NGNP High Temperature Materials White Paper

INL/EXT-09-17187

Revision 1

In the letter dated May 9, 2012, NRC issued NGNP – Assessment of White Paper on High Temperature Materials. This letter forwards a report assessing the contents of a white paper submitted by the NGNP and responses for RAIs submitted by the NRC after preliminary review. The NRC stated that the staff will not provide a final conclusion regarding the design and qualification of any NGNP components, materials, or their use in the plant design, until an NGNP combined license or design certification application is received and reviewed.

Figure 5. Comparison of the MTR data and PBMR Demonstration Power Plant service conditions.

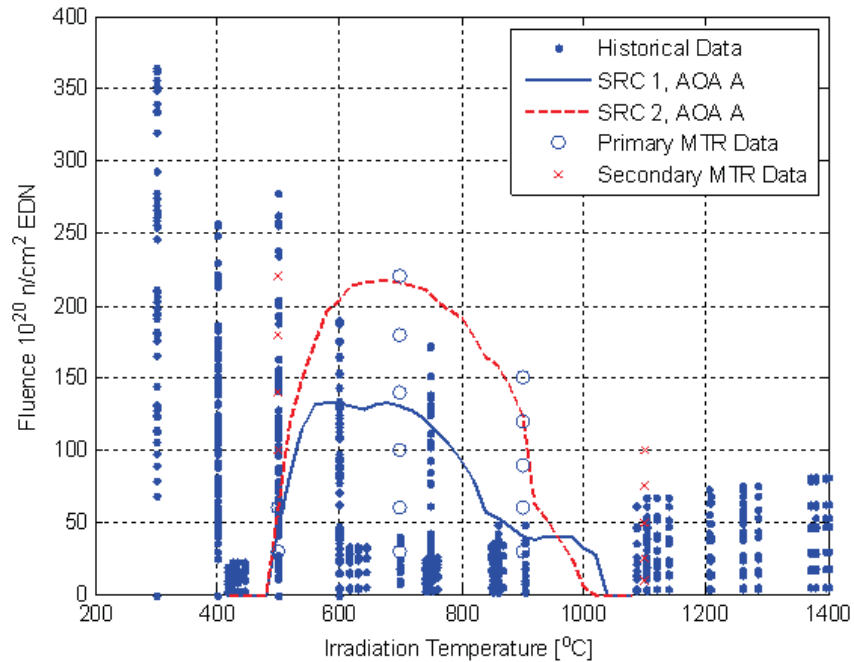
As an example, Figure 5 illustrates the relationship between the legacy German database and the PBMR Specific Materials Test Reactor Program irradiation conditions that were selected earlier for the proposed PBMR Demonstration Power Plant in South Africa. The solid blue line in the figure represents the projected temperature-fluence envelope at the end of service life for components that serve a structural function (SRC-1, as defined in Table 4), whereas the dotted red line denotes a similar envelope for the most highly-irradiated nonstructural components adjacent to the pebble fuel (SRC-2). As shown in Figure 5, the primary and secondary MTR data are designed to both confirm the applicability of the historical data and to supplement that data where required.
